REMARKS

Applicant graciously appreciates the Office's attention to the instant application. In view of the following remarks, Applicant respectfully requests reconsideration and allowance of the subject application. This amendment is  
5 believed to be fully responsive to all issues raised in the July 20, 2004 Office Action.

FIG. 12

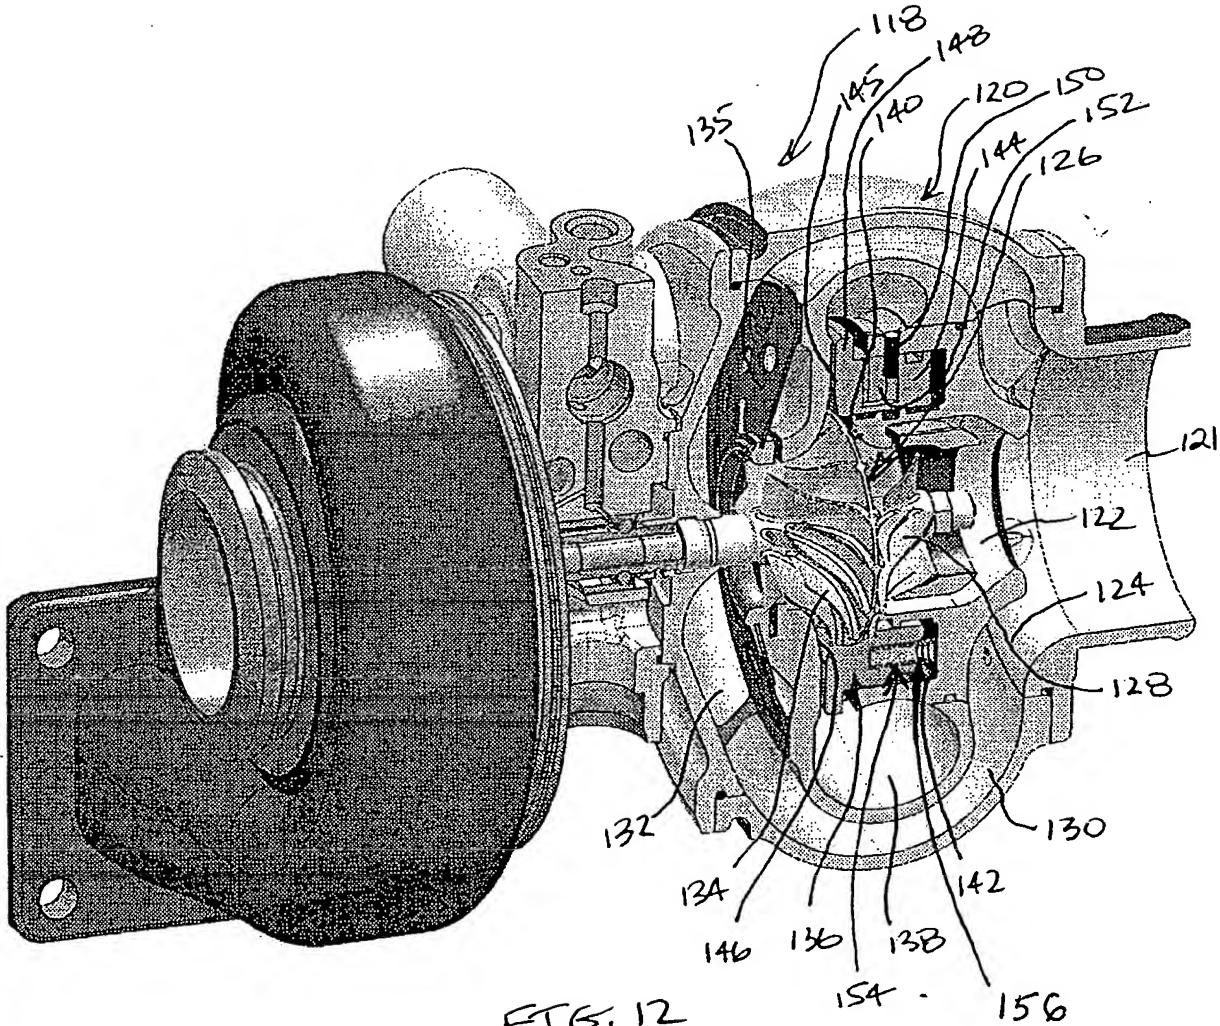
Applicant has amended Figs. 12 and 13 per suggestions by the Office. Applicant notes that a label for "slot 170" did appear in Fig. 13 for the means in an "unactuated" position (upper portion of figure). To clarify, Applicant has  
20 added a label for the means in an "actuated" position (lower portion of figure).

The attached sheets of drawings includes changes to Fig. 12 and to Fig. 13. These sheets replace the original sheets for Fig. 12 and for Fig. 13, respectively. In Fig. 12, previously omitted element "one or more springs 156" has been added. In Fig. 13 the element "a slot 170" appeared in the upper portion of figure for the "unactuated position" but did not appear in the "actuated position" in the lower portion of the figure. Thus, a label to the slot 170 has been added to the lower portion of the figure.
